MODIFICATION DESCRIPTION

When using the headsets VMP-36-PEL-A and VMP-36-PELP-A together with VMP stations **VMP-503** and **VMP-530** a “Modification cable kit with diode for VMP-stations” – pn 3005020067 needs to be added to the station to avoid disturbing oscillations (howling).

Picture 1:

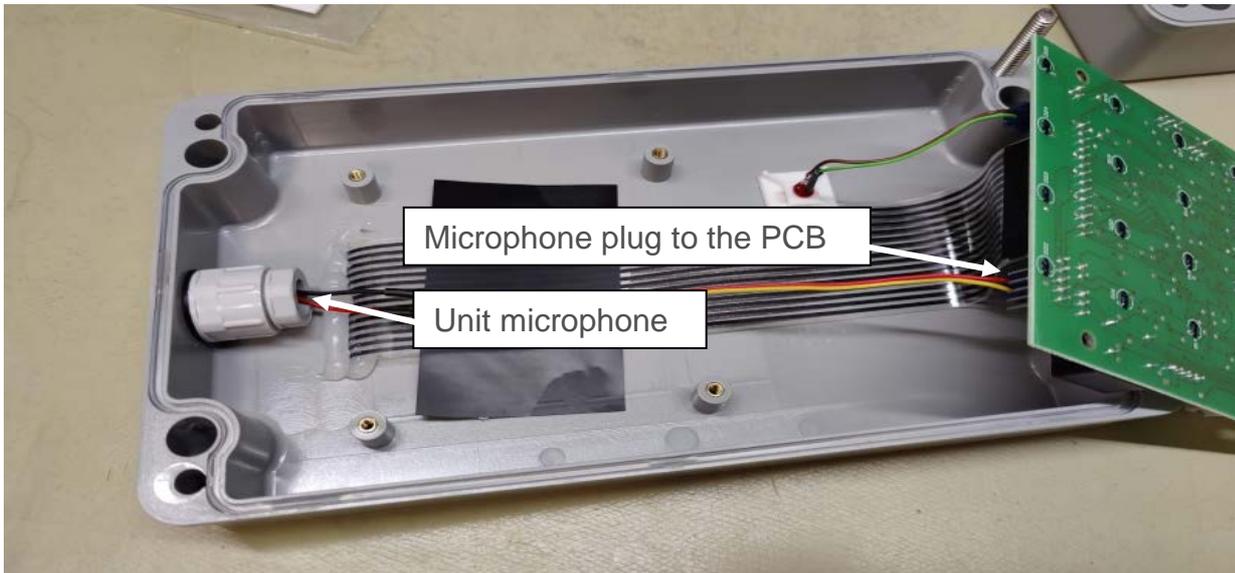
1. **Turn off the power to the complete system**
2. Open the unit
3. Unplug the internal microphone (pluggable) from the PCB – See the picture 1 below
4. Insert the Modification cable kit (Make sure colour codes and connector polarity is consisting with the existing microphone and connector (red-to-red /yellow-to-yellow) – See Picture 1/Figure 2 below
5. Reconnect the internal microphone/Microphone cable kit with diode for VMP stations to the PCB
6. Connect the headset
7. Close the unit
8. **Turn the system power on again**
